1 Building Elevation - South Frontage
1 : 200

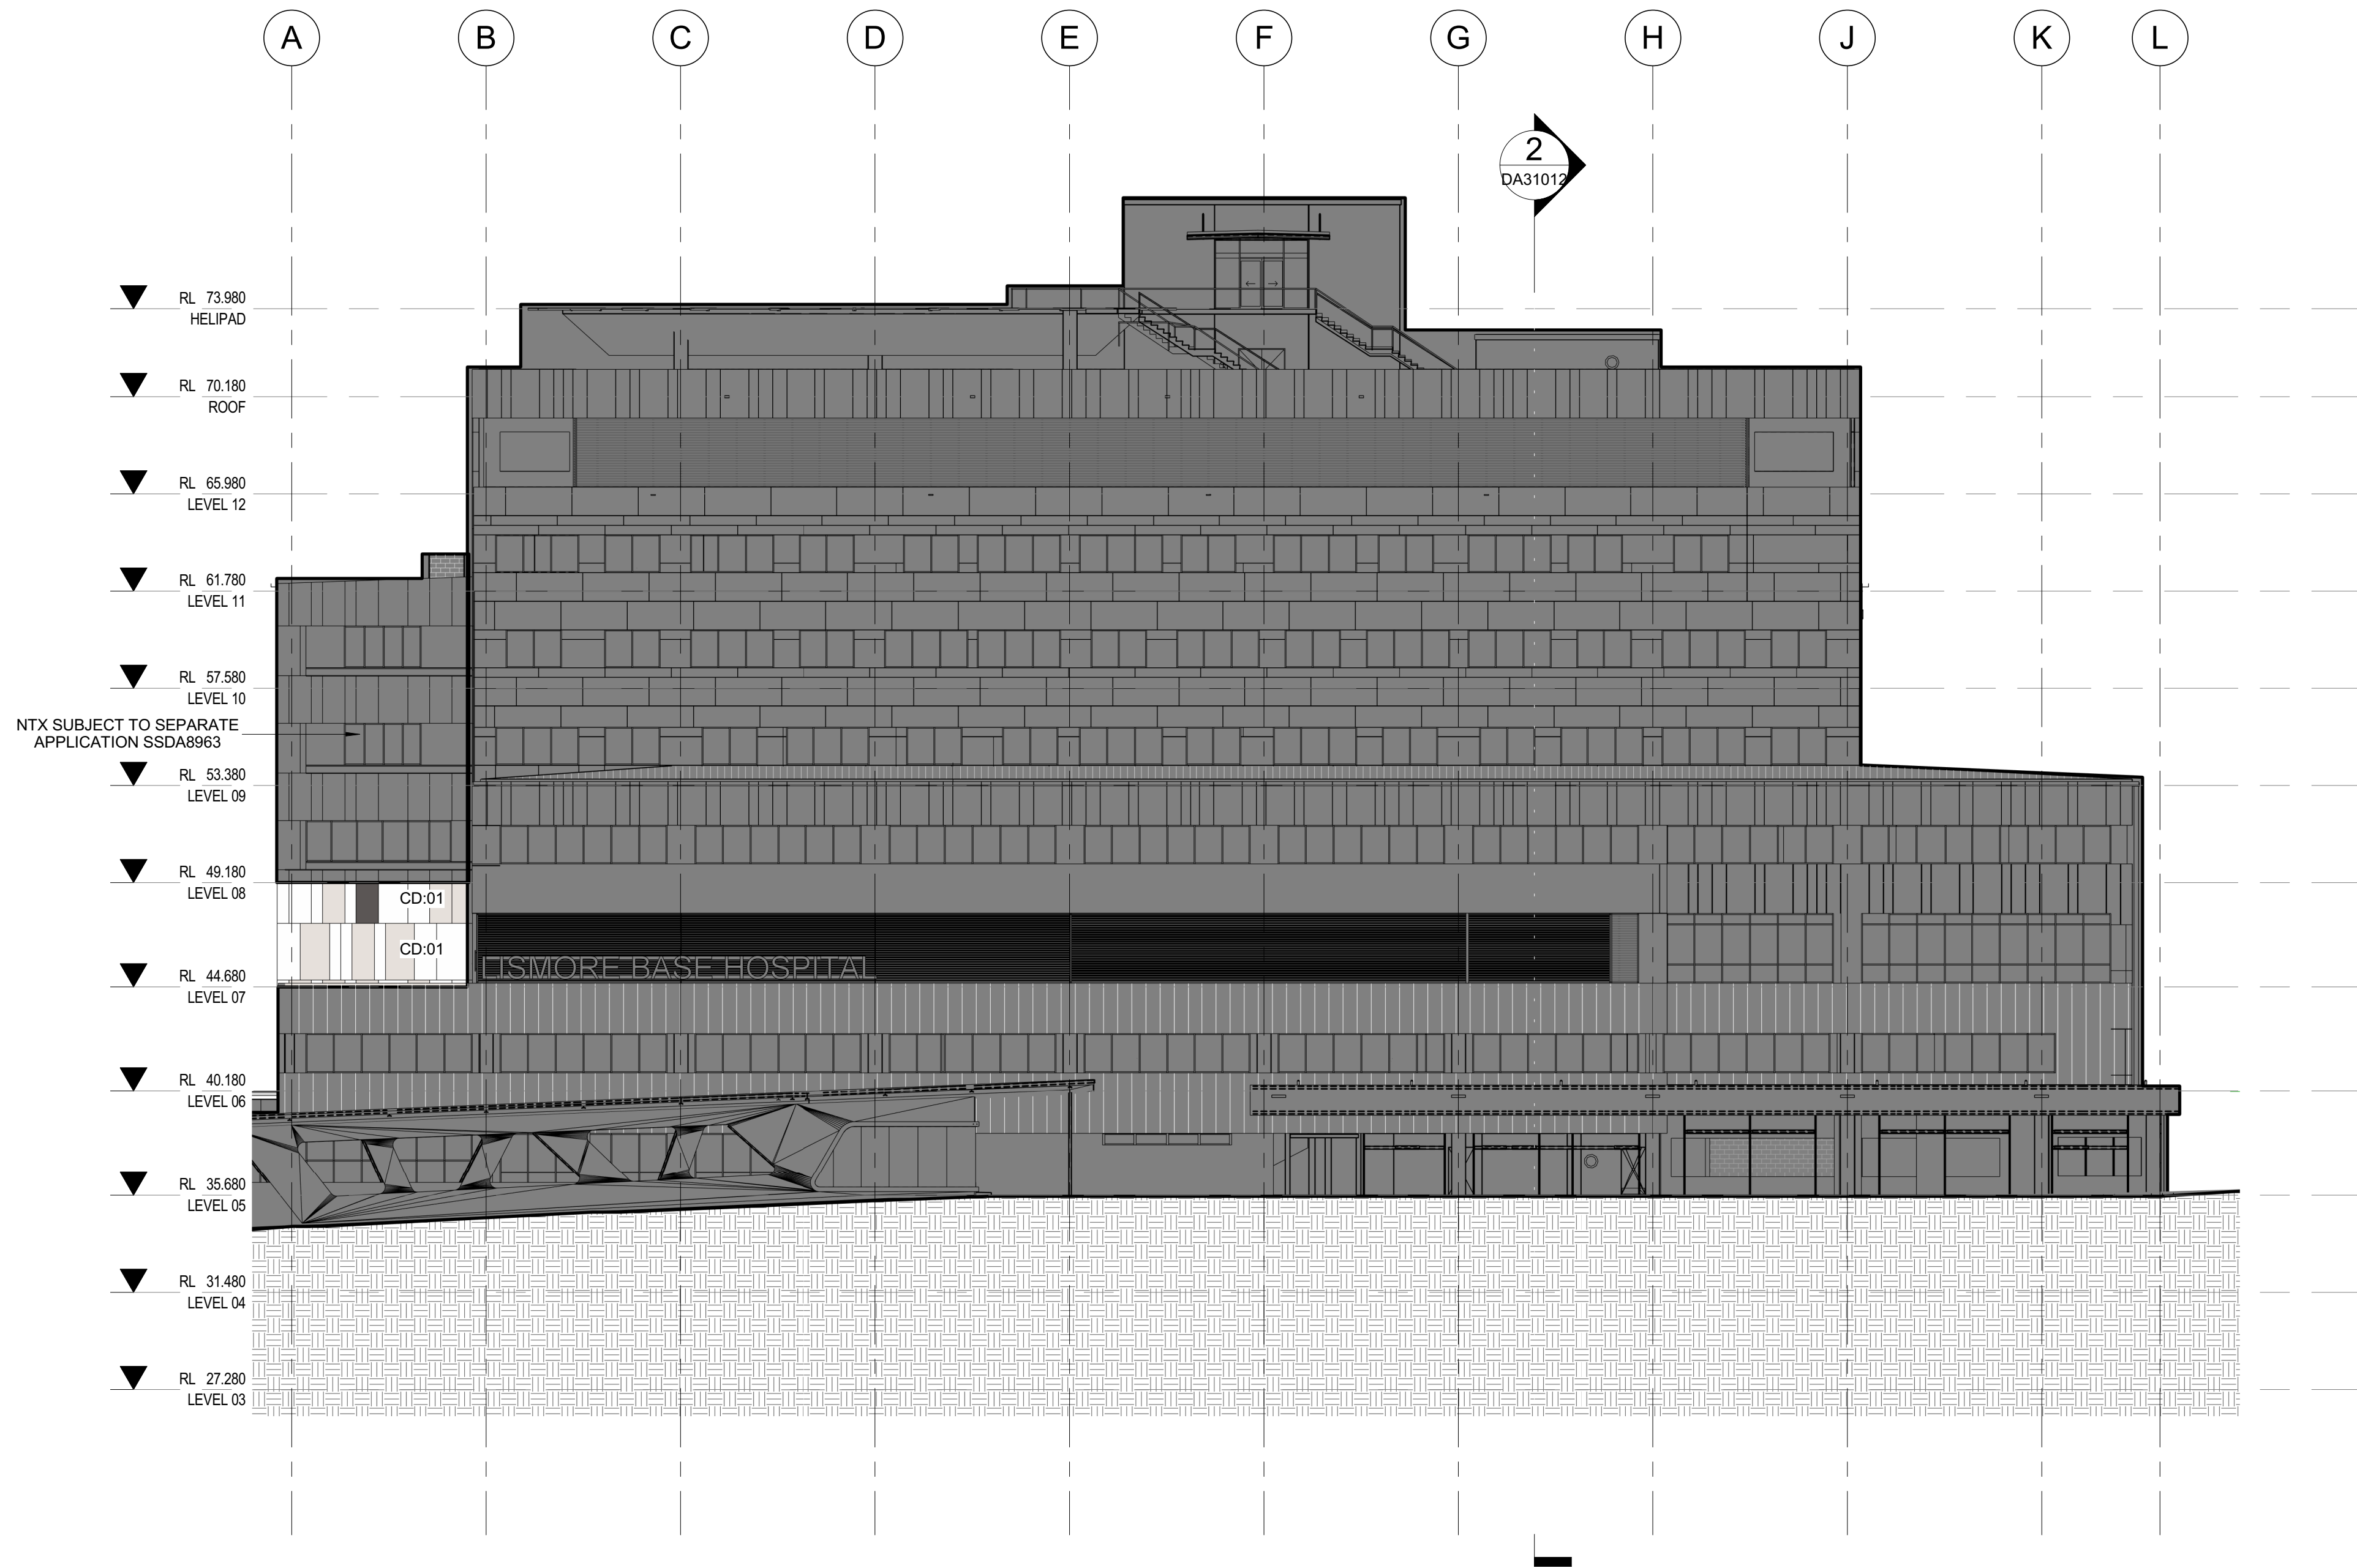
Schedule of Changes	
Item	Comments
1	Incorporation of quench pipe box on Northern Facade
2	Amendment of design language to facade
3	Change of colour palette to facade
4	Incorporation of large removable window for MRI
5	Incorporation of elevated walkway to Level 04
6	Reconfiguration of Level 03 to accommodate altered plant as a result of extension
7	Level 03 extent of louvre panelling reduced
8	Coordination of Mechanical design with external louvres
9	Windows amended suit internal layout
